SERVICE BULLETIN NO: 32-025 REF NO: 126

MODIFICATION NO: EC-08-0400 ATA CHAPTER: 32

LANDING GEAR - MAIN GEAR REPLACEMENT OF THE MAIN-GEAR SUPPORT STRUT

Support Strut Removal/Installation Figure 1

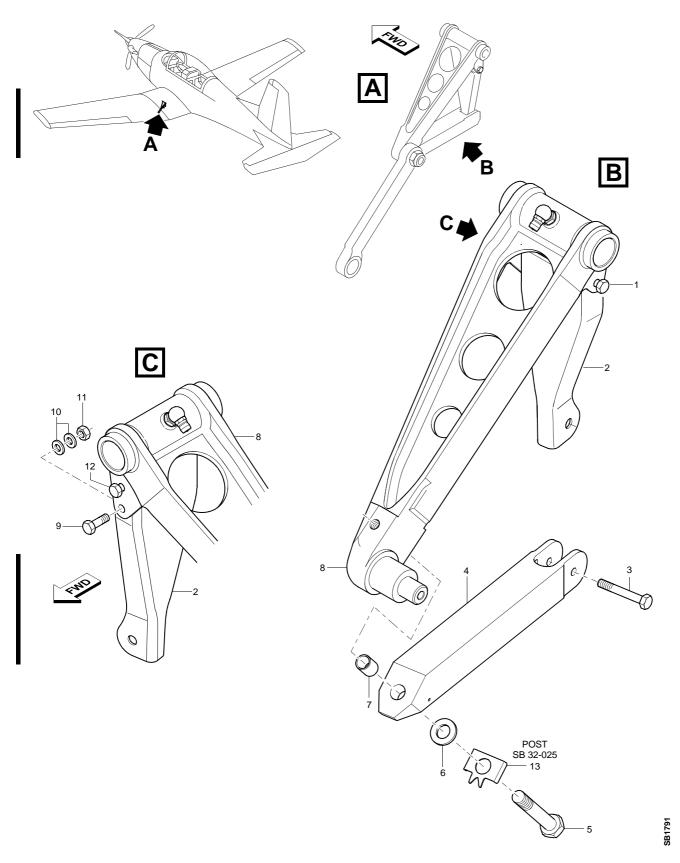
- Remove the main-gear folding-strut assembly (Ref. AMM 32-10-02, Page Block 401).
- B. Remove the Main-Gear Support Strut (Ref. Fig. 1)
 - (1) Remove and discard the lockwire from the bolt (5).
 - (2) Remove and discard the bolt (5), the washer (6) and the bush (7) that attach the main-gear support strut (4) to the upper folding strut (8).
 - (3) Loosen, but do not remove, the bolts (1) and (12).
 - (4) Remove the nut (11), the washers (10) and the bolt (9).
 - (5) Move the folding strut lever (2) away from the main-gear support strut (4).

- (6) Remove the main-gear support strut (4). If the main-gear support strut (4) is difficult to remove, apply heat to the area.
- (7) Discard the main-gear support strut (4).
- C. Install the New Main-Gear Support Strut (Ref. Fig. 1)

- (1) Apply a layer of corrosion preventative compound (Mat. No. P04-012) to the bush (7) (114.48.07.133) and put it in position in the upper folding strut (8).

- (2) Temporarily install, but do not fully tighten, the bolt (5) (P/N 932.35.14.227), the lock washer (13) (P/N 532.10.09.133) and the washer (6) (P/N 938.75.11.311) to attach the main-gear support strut (4) (P/N 532.10.09.128) to the upper folding strut (8).

- (10) Torque the bolt (5) (P/N 932.35.14.227) to between 7,0 and 9,5 Nm (60 and 85 lb. in.).
- (11) Safety the bolt (5) (P/N 932.35.14.227) with the lock washer (13) (P/N 532.10.09.133).
- (12) Apply a layer of corrosion preventative (Material No. P10-013) to the head of the bolt (5) (P/N 932.35.14.227), the lock washer (13) (P/N 532.10.09.133) and the washer (6) (P/N 938.75.11.311).
- (13) Install the bolt (9), the washers (10) and the new nut (11) (P/N 938.07.68.305).
- (14) Tighten the nuts on the bolts (1) and (12) and the new nut (11) (P/N 938.07.68.305) to between 3,4 and 4,5 Nm (30 and 40 lb. in.).
- (15) Remove the bolt (3).
- (16) Install the main-gear folding-strut assembly (Ref. AMM, 32-10-02, Page block 401).

Make the Holes in the Main-Gear Support Strut the Correct Size Figure 2

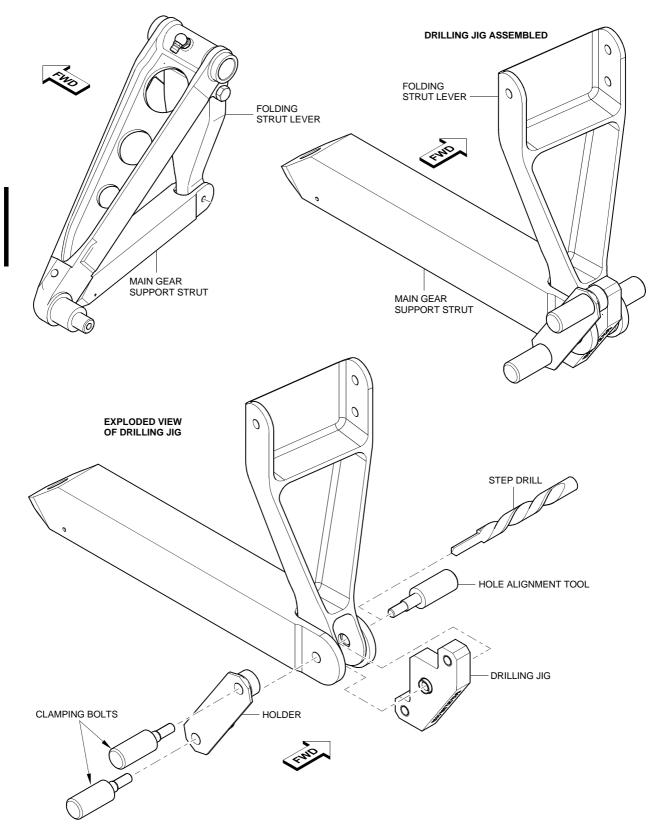
- (3) Engage the folding strut lever (2) in the main-gear support strut (4).
- (4) Make the Holes in the Main-Gear Support Strut the Correct Size (Ref. Figs. 1 and 2)

- (a) Put the drilling jig (P/N 513.32.09.119) into one of the holes in the folding strut lever (2). Make sure the step on the drilling jig (P/N 513.32.09.119) engages in the hole of the folding strut lever (2).

- (b) Put the holder (P/N 513.32.09.120) in position on the drilling jig (P/N 513.32.09.119) and install the two clamping bolts (P/N 513.32.09.123). Do not tighten the two clamping bolts (P/N 513.32.09.123).

- (c) Use the hole alignment tool (P/N 513.32.09.124) to align the holes in the folding strut lever (2) and the main-gear support strut (4) (P/N 532.10.09.128).

- Tighten the bolts (1) and (12)
 - Tighten the two clamping bolts (P/N 513.32.09.123)
 - Tighten the bolt (5).
- (e) Use the step drill (P/N 513.32.09.122) to increase the diameter of the other hole in the main-gear support strut (4) (P/N 532.10.09.128) to 7.6 mm.

- (g) Put the holder (P/N 513.32.09.120) in position on the drilling jig (P/N 513.32.09.119) and install the two clamping bolts (P/N 513.32.09.123).
- (h) Use the step drill (P/N 513.32.09.122) to increase the diameter of the other hole in the main-gear support strut (P/N 532.10.09.128) to 7.6 mm.

- (n) Remove the main-gear support strut (4) (P/N 532.10.09.128).
- (o) Use the reamer (P/N 901.80.02.030) and increase the diameter of the holes in the main-gear support strut (4) (P/N 532.10.09.128) to 7.938 + 0.015 0.0 mm (0.3125 + 0.0006 0.0 in.).
